USNRC APPLICATION
SUA-1341 License Amendment
Ludeman Project
Converse County, WY

June 2013

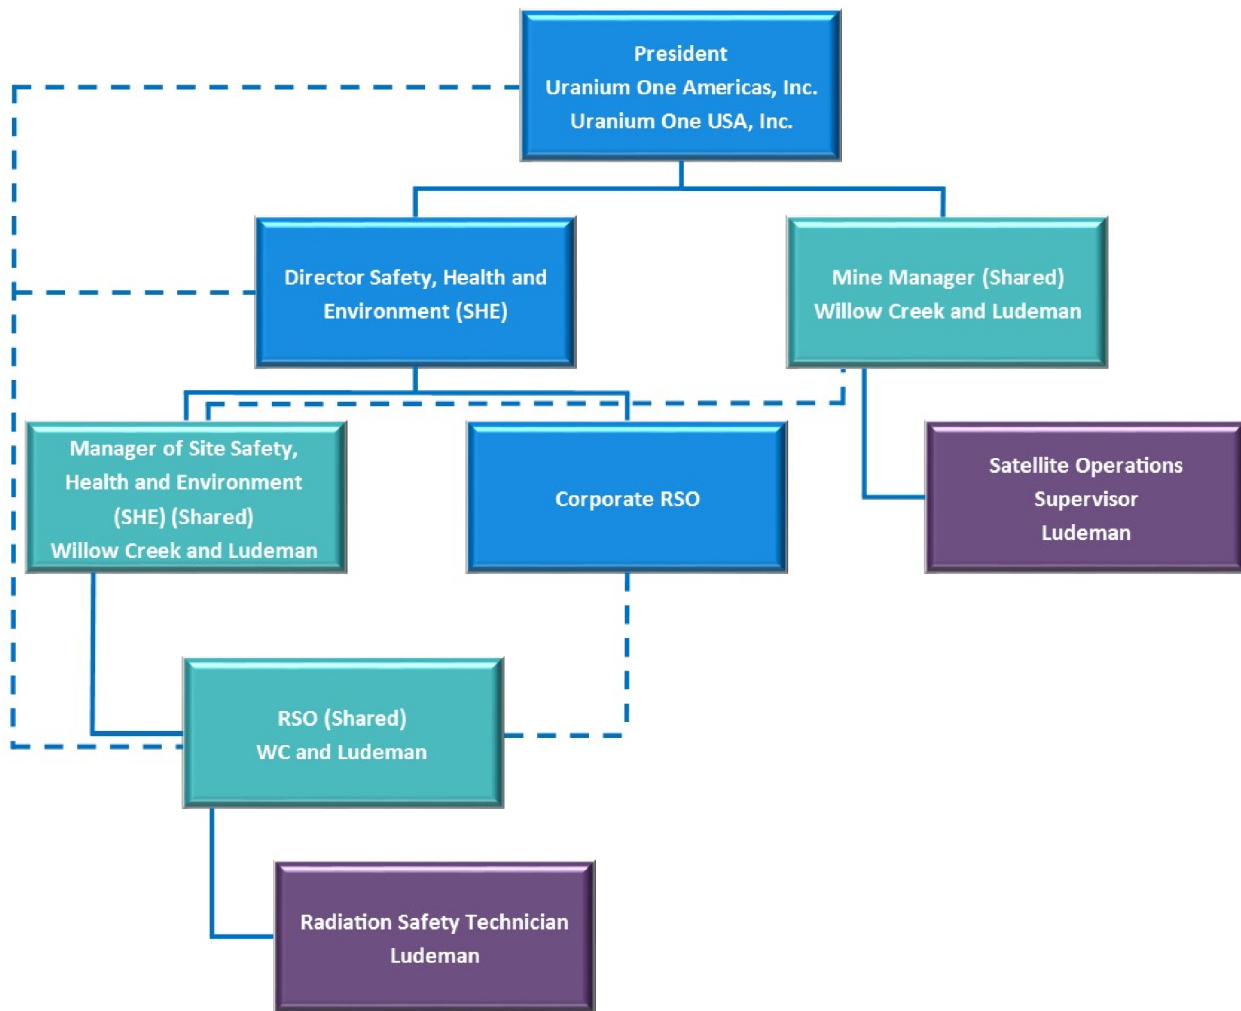
Section 5.1, Figure 5-1 is titled, “Uranium One USA, Inc. Organizational Chart”

Uranium One should revise Sections 1 and 5 of the TR, and all other applicable sections of the TR, to provide a consistent management structure for the Ludeman facility.

Management positions described in Sections 5.1.1 – 5.1.8 of the TR are not always consistent with the organization chart provided in Figure 5-1.

Sections 5.1.4, 5.1.5, and 5.1.7 reference a position titled, Manager Site SHE. Figure 5-1 identifies a position titled Manager Satellite SHE

Uranium One should revise Section 5.1 of the TR, and all other applicable sections of the TR, to ensure that the management positions identified on Figure 5-1 are consistent with the position descriptions described in Sections 5.1.1 – 5.1.7.

Text and figures concerning organizational structure have been revised throughout the application to clarify and provide a consistent management structure. Revisions to specific sections are provided below:

Figure 5-1 was be modified to indicate the position as Manager Site SHE. The position of Director of Operations was eliminated on Figure 5-1 and its corresponding responsibilities will be incorporated into the Mine Manager position. See RAI-1 for the revised organizational structure figure and position descriptions.

Figure 2: GCC Stability Class Distribution

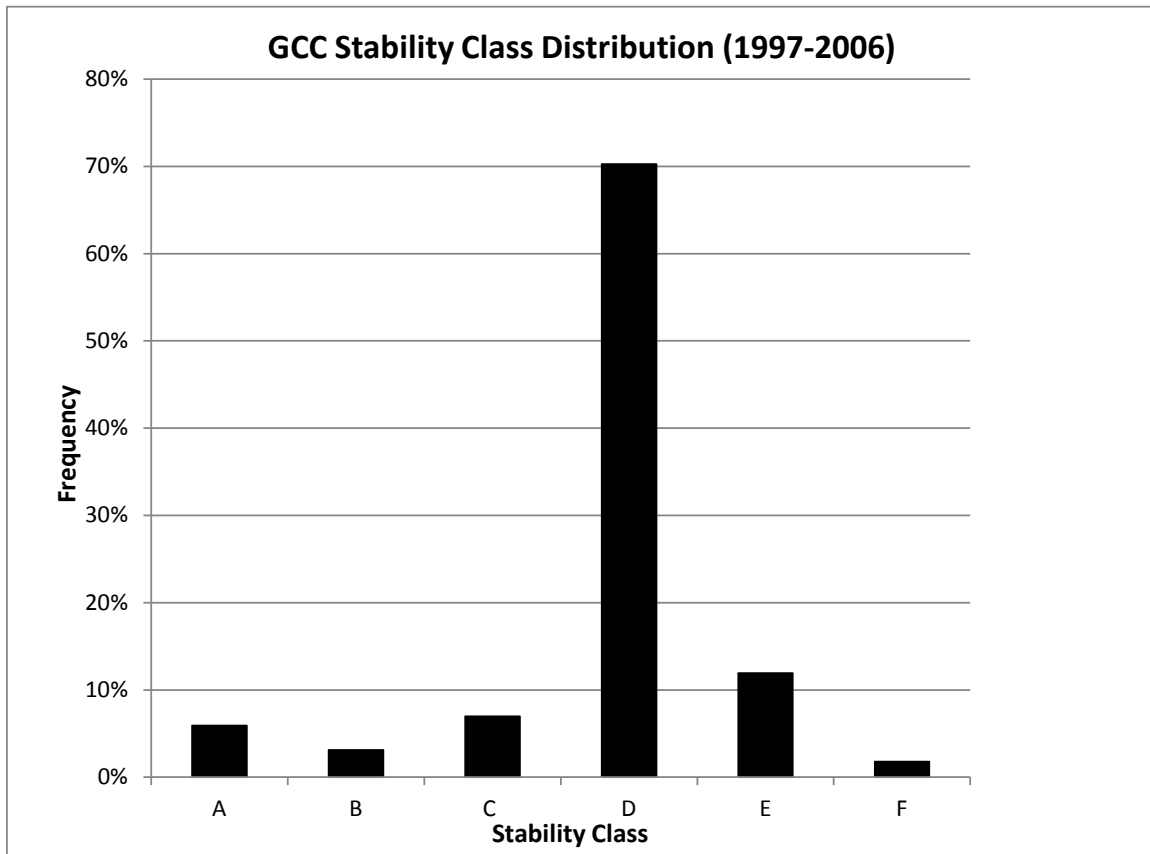
Provide the relative frequency of each stability class for the Douglas Airport and GCC meteorological stations, and describe how these stability classes were determined

The figure below shows the atmospheric stability class distribution at GCC for the 10-year period from 1997 through 2006. Note that the NWS station at Douglas Airport does not log sigma theta; therefore hourly stability class cannot be determined. Note also that in keeping with the above response to TR RAI 3, the on-site stability class distribution for the Ludeman Project will be generated at the end of the baseline monitoring period.

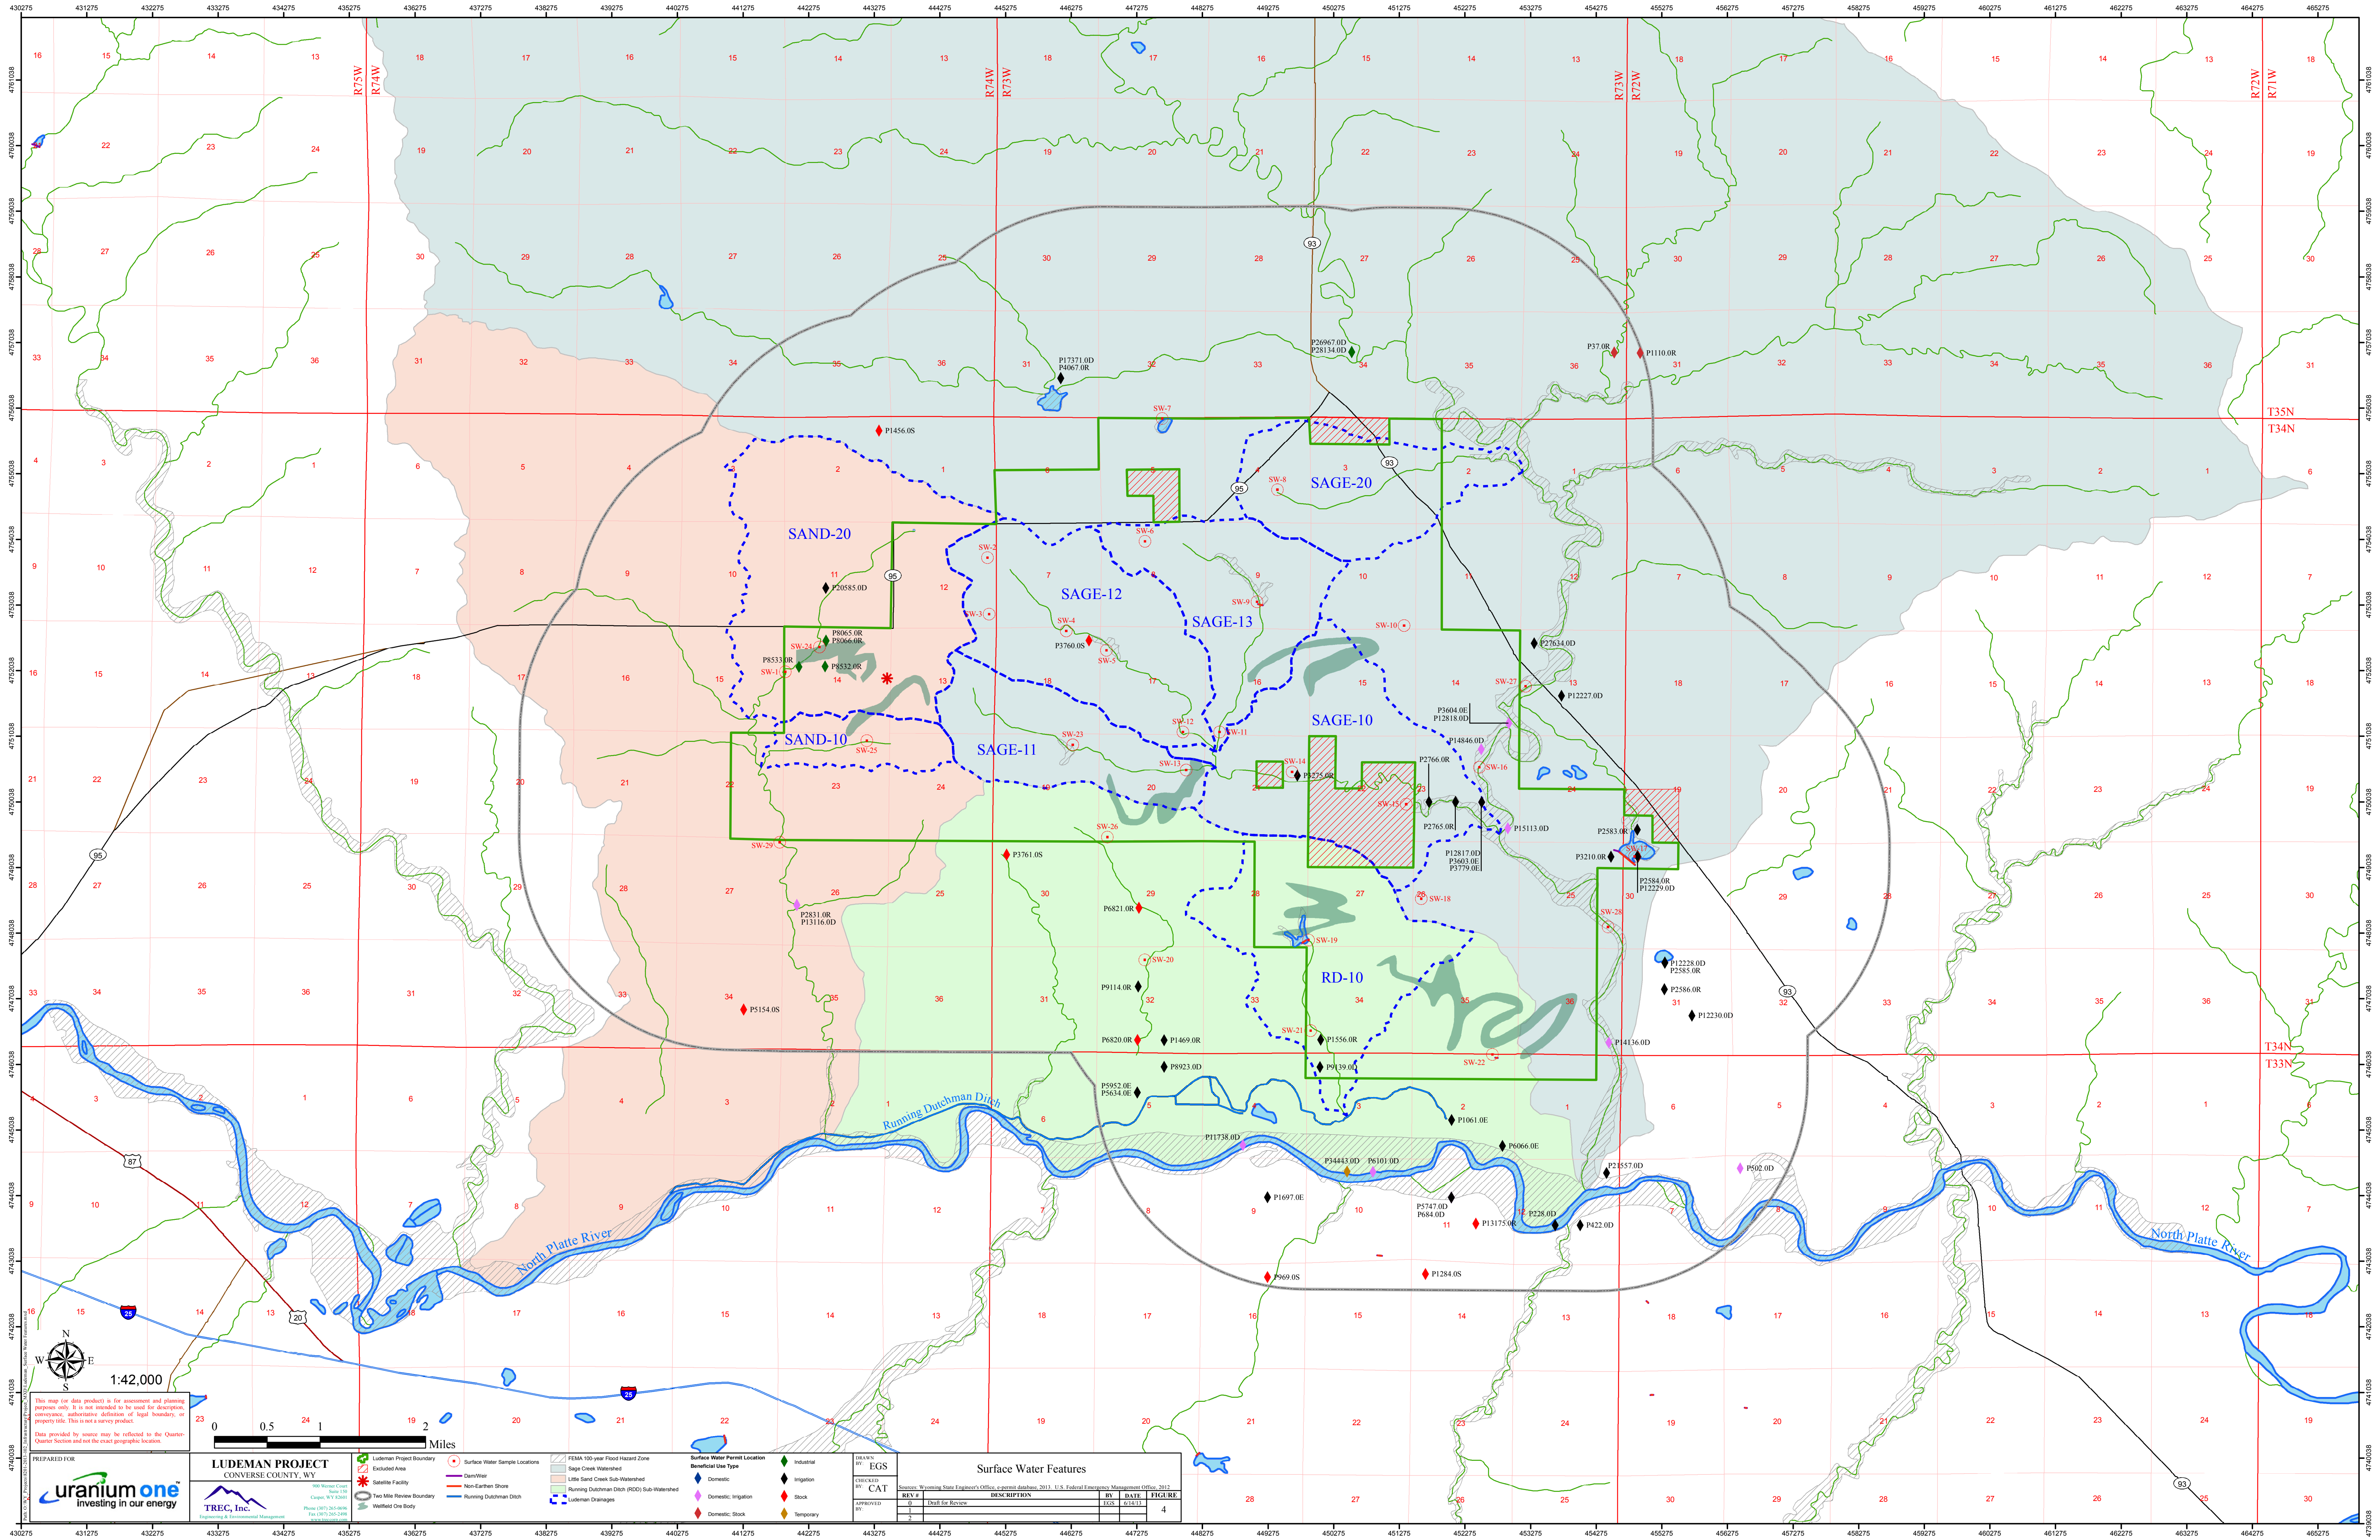
Uranium One identified eight smaller drainages within the sub-watersheds in the license area which are shown in Figure 2.7.2 of the TR. The location of the satellites and wellfields were not shown on this figure.

Staff was not able to assess the locations of the proposed wellfields relative to the eight smaller drainages to have reasonable assurance that the drainage channels would not impact the safety of operations.

Provide maps showing the location of all proposed satellite wellfields relative to the eight smaller drainages.

The following figure is now included in Section 2.7 and depicts the proposed wellfields relative to the six smaller drainages:
